Re: Concerns with 850 Route 28 LLC Construction and Operation (the "Project")

The following is our response to Steve Mallory's concerns with 850 Route 28 LLC Construction and Operation (the "Project") dated 04/15/2019.

#### RE: Response to Steve Malloy Comments On 850 Route 28 LLC Project Dated 04/15/2019

A revised Figure 2 is attached showing the location of the front end loader loading shot rock into a tractor trailer, and the distances to each residence.

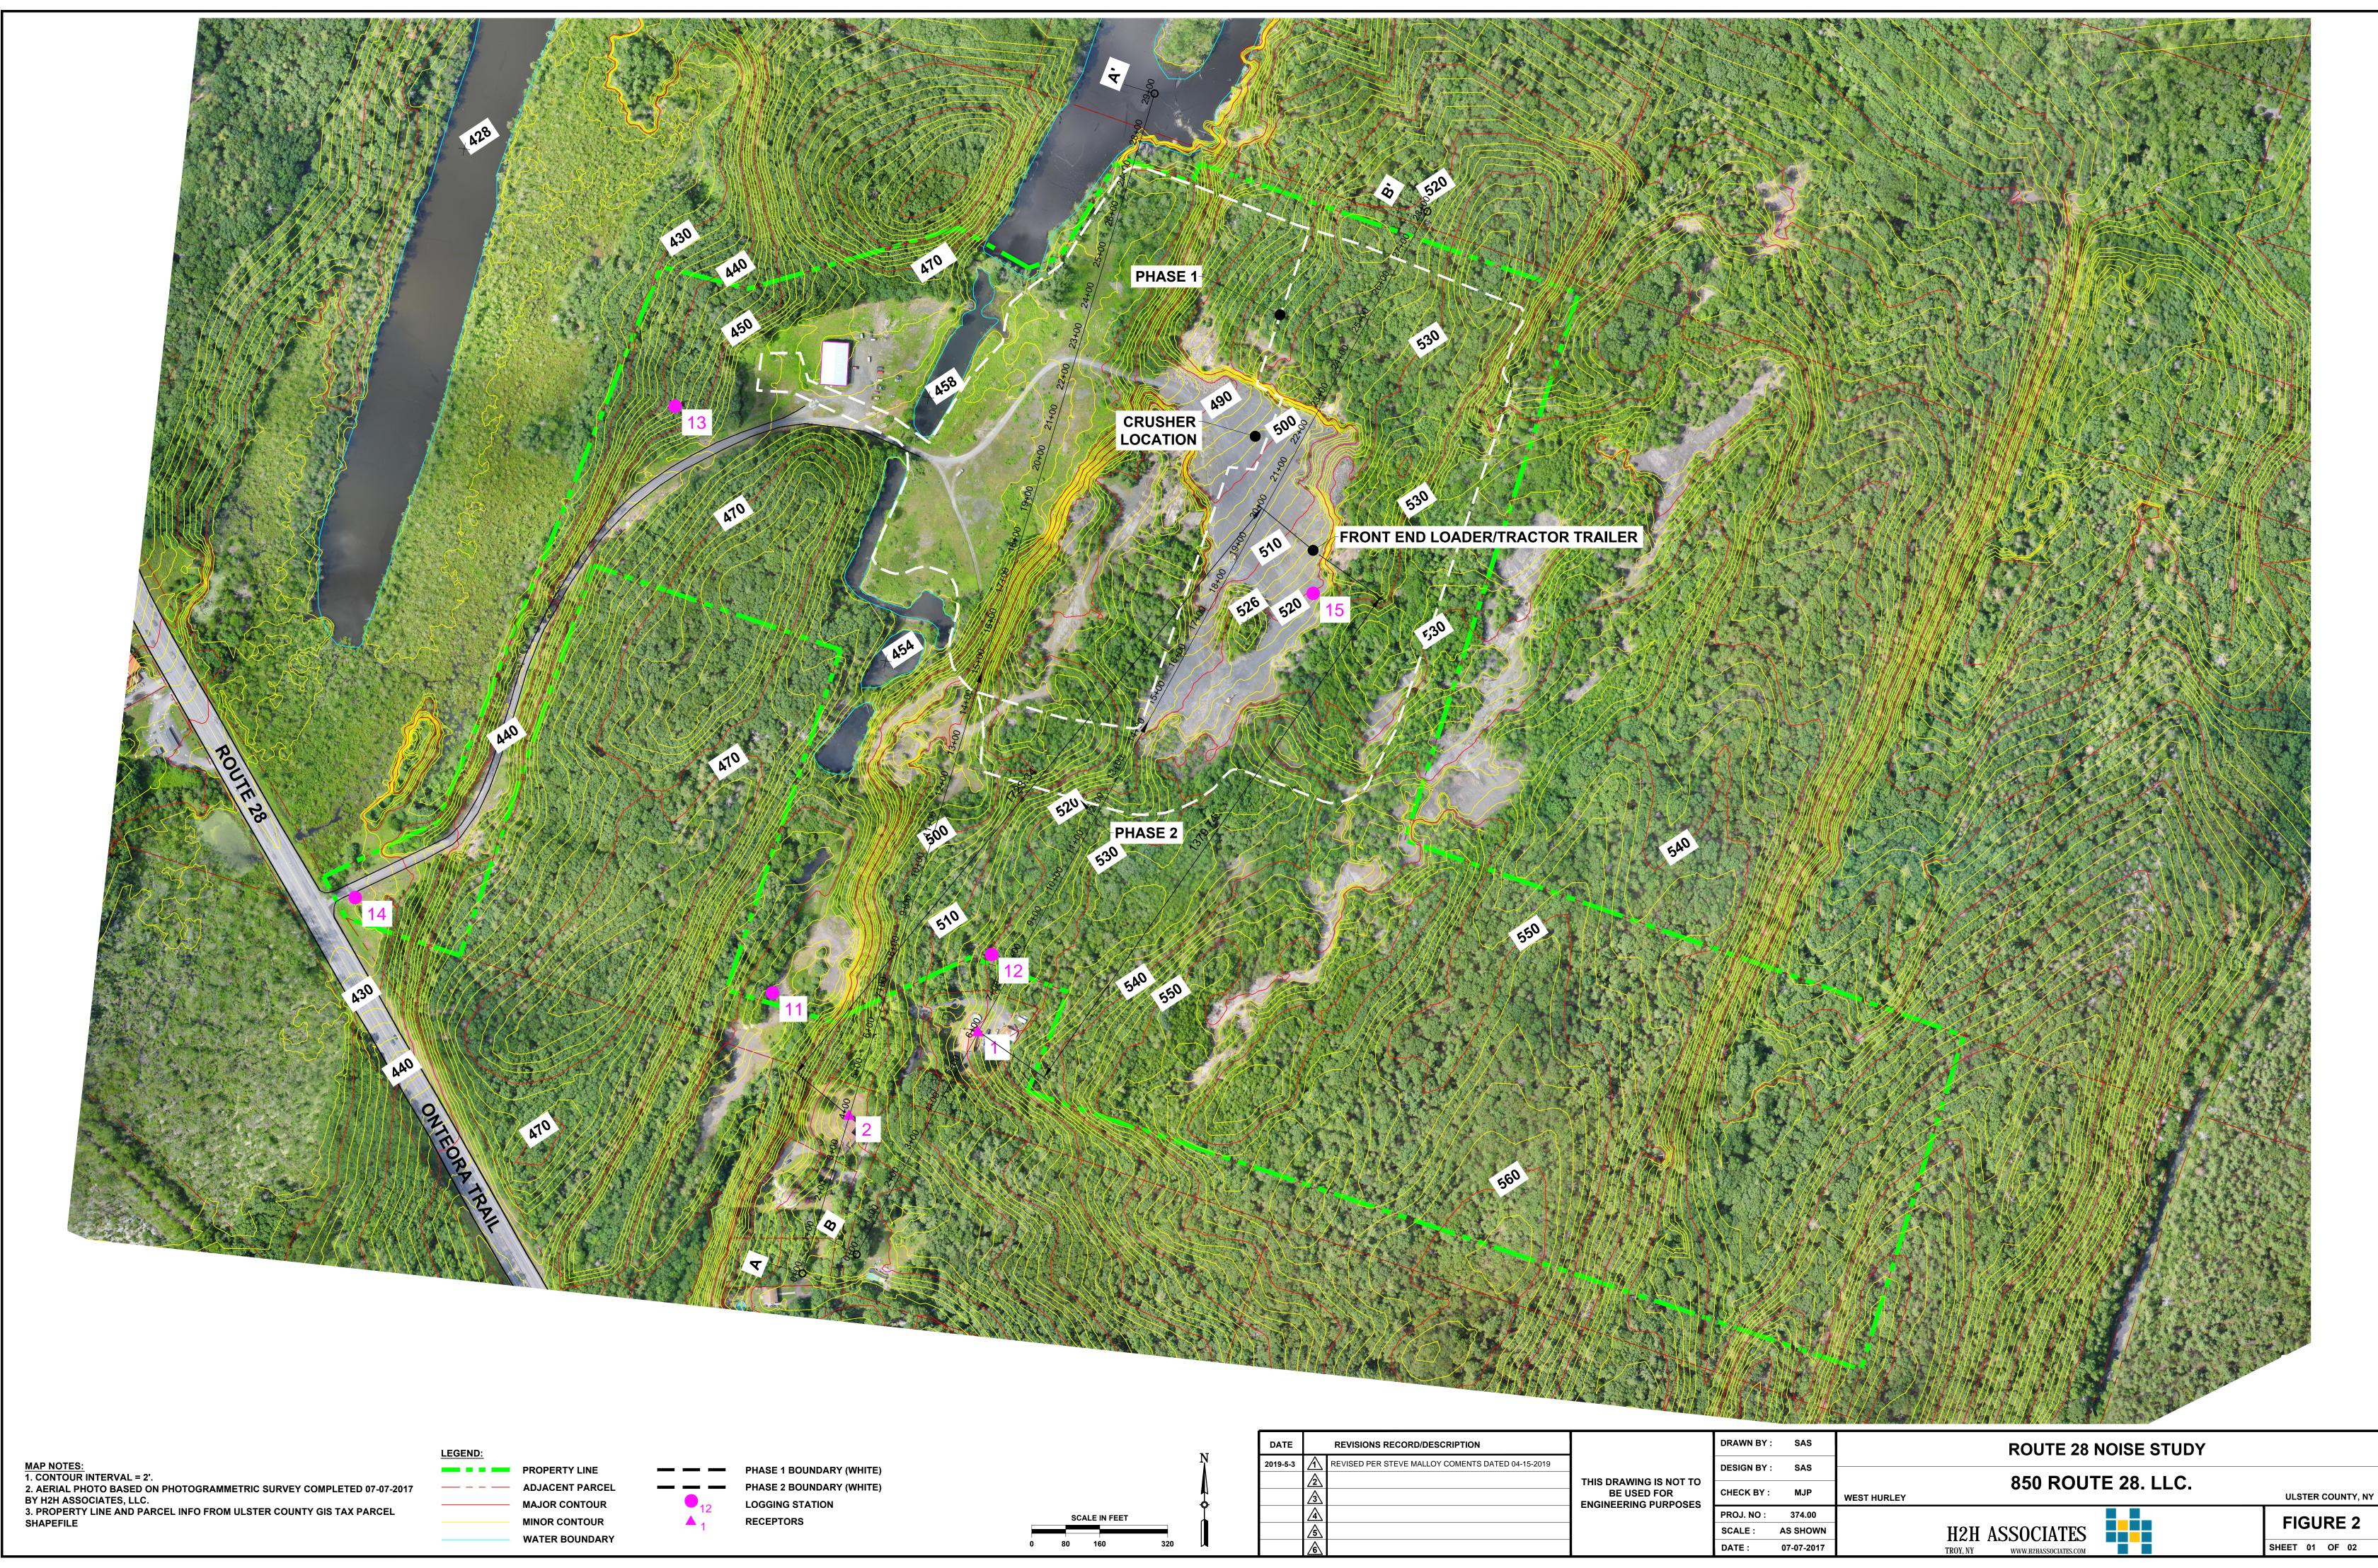
## 4. The report does not note where the front end loader loading into the tractor trailer was in relation to the logging stations. That should be noted on the drawing showing distances to residence.
